SUBJECT: NO DIGITAL RECORDING

MODEL (S): MZ-R3

MT-MZR3-109

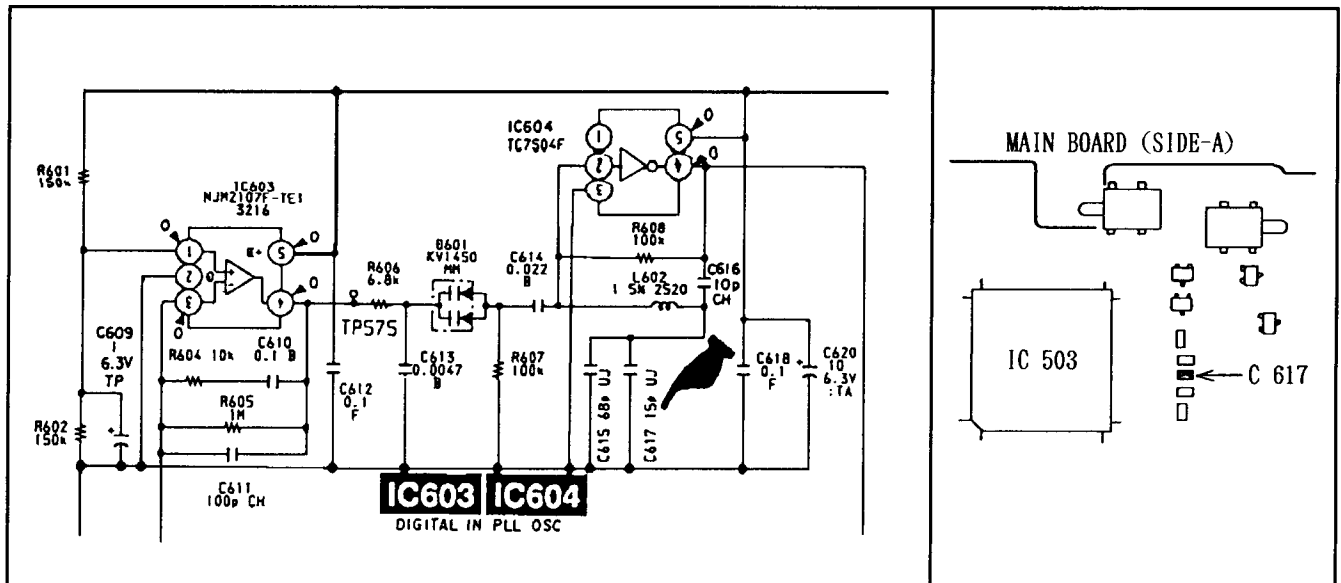
CAUSE:

Narrow digital PLL locking range.

- Confirm whether the voltage at IC603 pin 4 on the Main Board ranges between 1.5V and 2V when a digital signal is input.
- If the voltage is smaller than 1.5V, replace C617 chip 15pF on the A side of the Main Board with chip 10pF.

Ref.	Former	New
C617	1-164-118-11 (15PF)	1-162-997-11 (10PF)
